Hydrophone Circuit Design Update

Figure 1: Protection circuitry

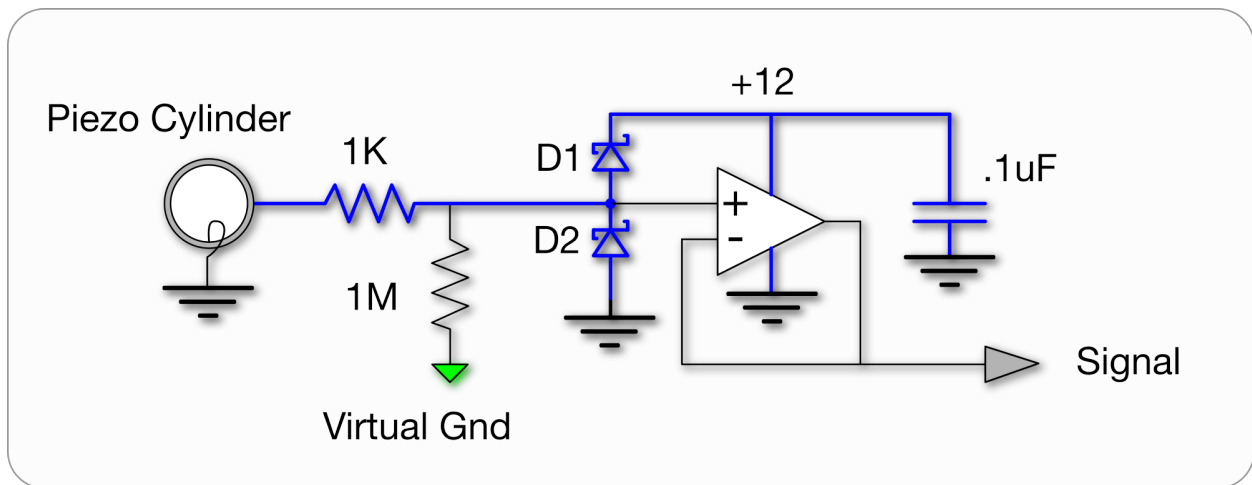
Both the original P48, and the dual 9-volt battery powered boards hydrophone boards have been updated to Revision 2. The main change is the addition of input protection for the operational amplifier used in the circuit. This is the OPA1642. It does include internal diode protection for shunting voltages above or below the power supply pins to those voltage rails. There were a few situations where that has not been sufficient. The circuitry now contains a series input resistor and two specialized diodes for protection. Those are Schottky diodes that are designed for this purpose. They conduct at a lower threshold voltage than a traditional silicon PN junction. They also feature a much faster conduction time. This circuit was robustly tested to ensure it functions properly. The addition to the original circuit is shown in blue.

The Piezo Cylinder has a natural resonant frequency of 43Khz. When tapped or struck, it will resonant a bit like a bell. Initially the voltage spikes can be in the 10's of volts if not higher. This has the potential to damage the input to the OPA1642. If the input voltage exceeds +12 D1 will start to conduct. If the input voltage swings negative below ground D2 will conduct. In either case the .1uF capacitor will initially appear as a low impedance. At 43Khz, it appears as a 370hm resistor.

There are no changes to the sonic qualities of the board. While the 1K and the 1M resistor form a voltage divider, it results in .1% change in output level, or -.008dB level change, which is imperceptible.
